**AGENDA
PLAN COMMISSION MEETING
RICHFIELD VILLAGE HALL
4128 HUBERTUS ROAD, HUBERTUS, WISCONSIN
September 10, 2020
7:00 P.M.**

SUBJECT: Site & Plan of Operation/Minor Land Division CSM – St. Augustine Catholic School
4908 Plat Road (Tax Key: V10_122100Z)

RE: Monches Properties LLC CSM

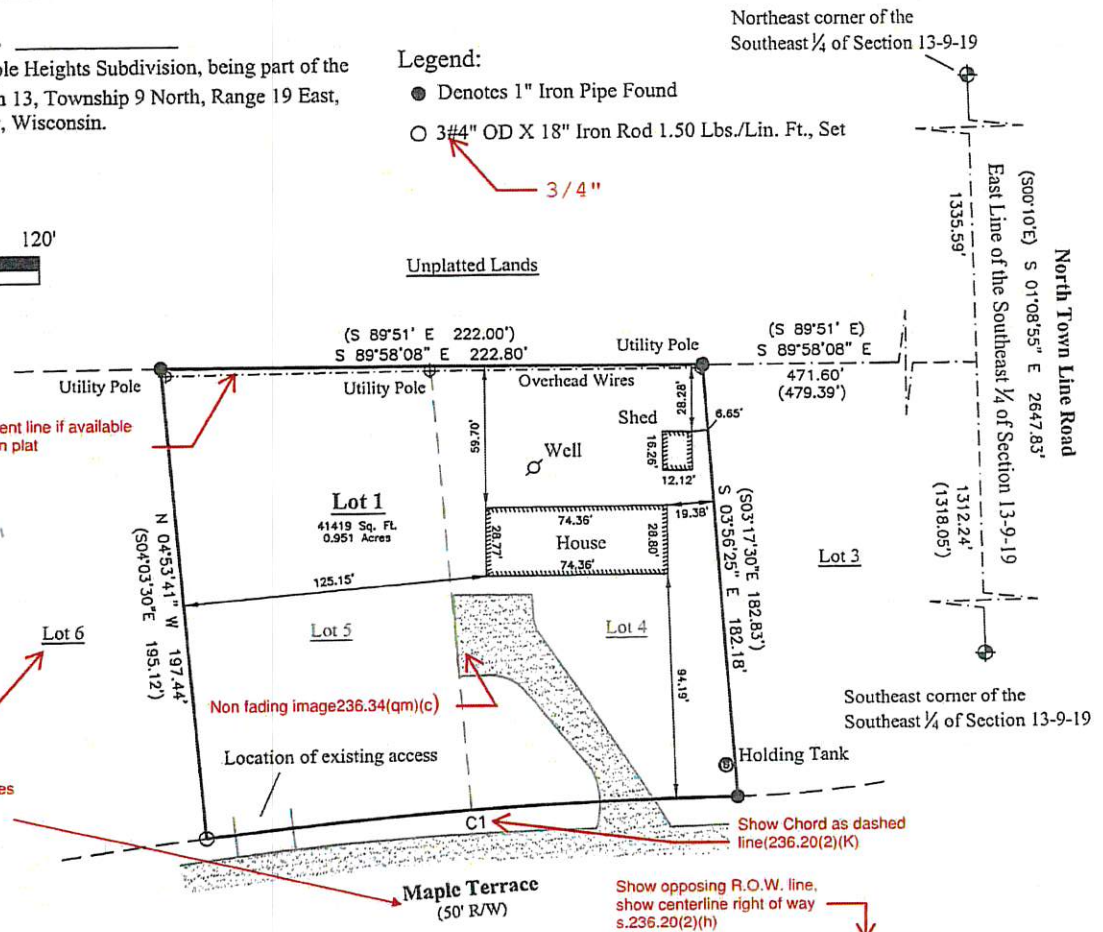
- Change all green hatch to non-fading black image per s.236.34(1m)(c)
- Underline with dashed or dotted lines for road names per s.236.20(3)d
- Show easement line if applicable from subdivision plat
- Show curve chord as dashed line per 236.20(2)(k)
- Setback information per Village of Richfield Code 330-34(2)
- Show opposing Right of Way Line width and centerline Maple Terrace per s.236.20(2)f/h

Show easement line if available
on Subdivision plat

Dashed or dotted lines
236.34(3)d

Village of Richfield Board Approval

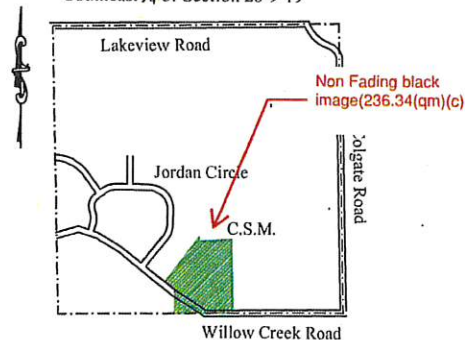
Generally Clerk information,
Village Website shows Donna
Cox. Verify and change if
necessary
